The Civil Engineers Woven Limited (Extension)

8, 9, 159 & 160 Baghbari, Horindhara, Hemayatpur, Savar, Dhaka, Bangladesh.

14 February 2024

2. Observations

Observation 1: Cursory calculation indicates the column and foundation is marginally overstressed. (Warehouse Steel Building)

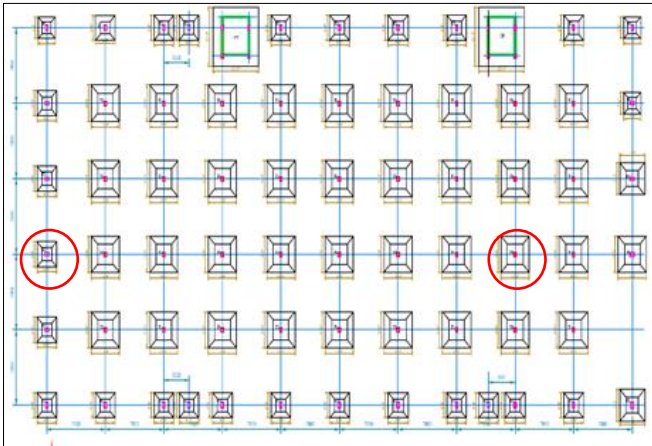
Description: The cursory calculation indicates that columns and footings are stressed above the normal design limit at the marked locations considering floor live load of 6 kPa for the typical floors. We have considered minimum concrete strength based on aggregate type (16.3 MPa), steel plate strength 345 MPa and rebar strength 415 MPa from the available test report. We have also considered ultimate soil bearing capacity 1.44 Ksf from available soil test report. The building engineer is required to review design loads, and column-foundation stresses based on in-situ material strength at the marked location. Also, produce and actively manage a set of floor live load plan.

Fig. Size & thickness of interior and exterior footing - F3

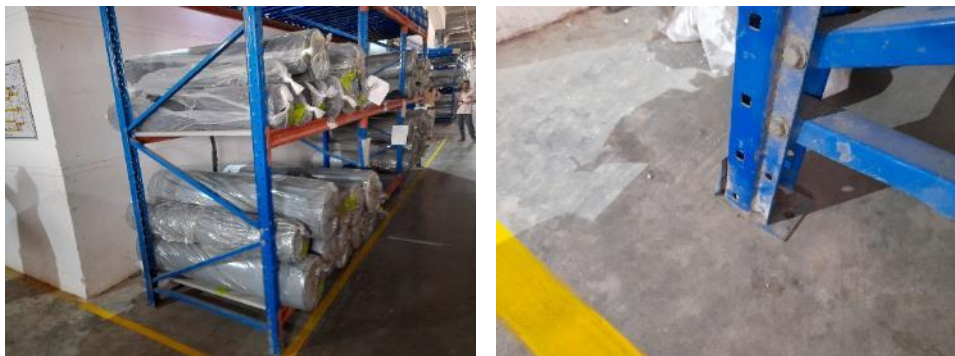
Description: The consideration of bearing capacity is not clear, cursory calculation from soil test shows less than the considered value. The building engineer is required to provide detailed clarification of specific sourcing of the values considered for the bearing capacity in the design report.
